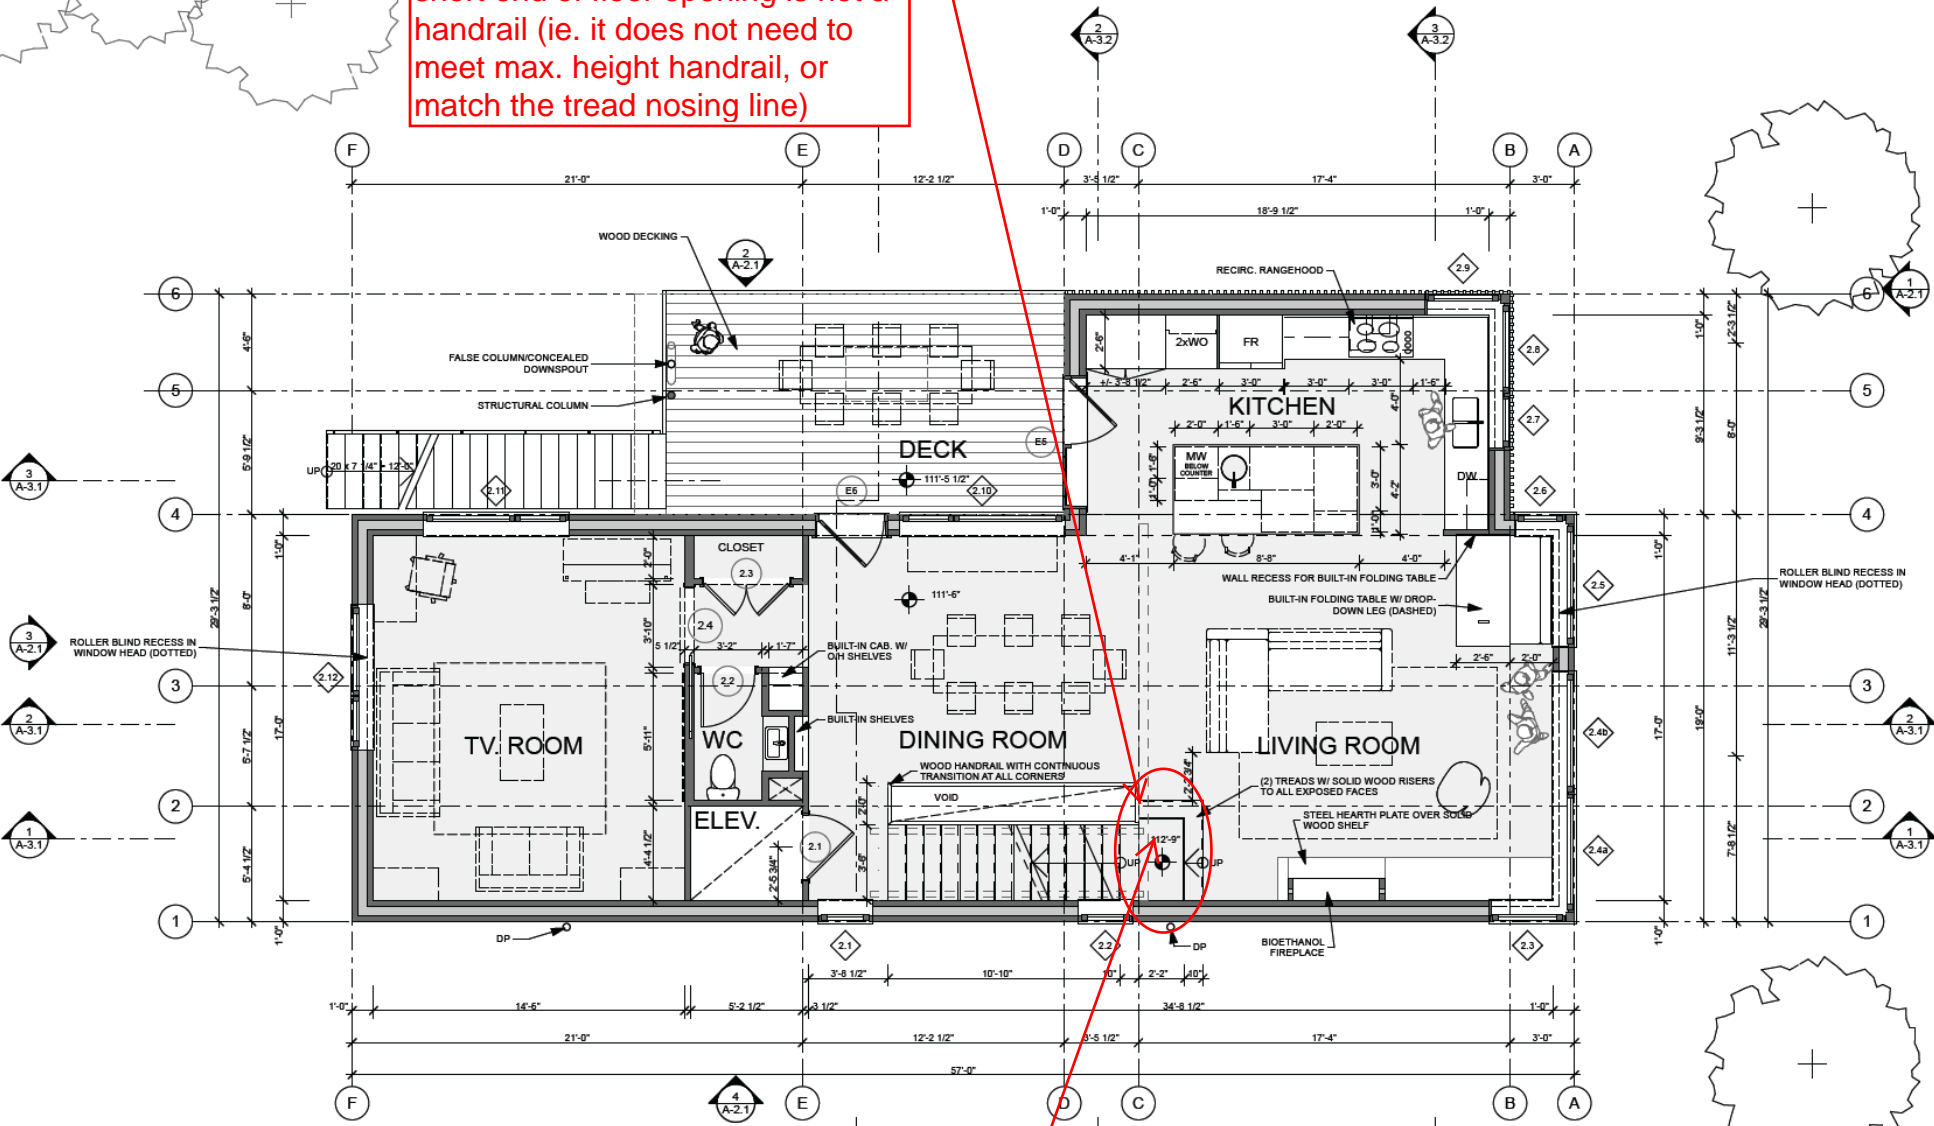
Top rail of balustrade guard at short end of floor opening is not a handrail (ie. it does not need to meet max. height handrail, or match the tread nosing line)

These 2 risers are considered elevations changes within the room per IBC-1009.12, exception 5
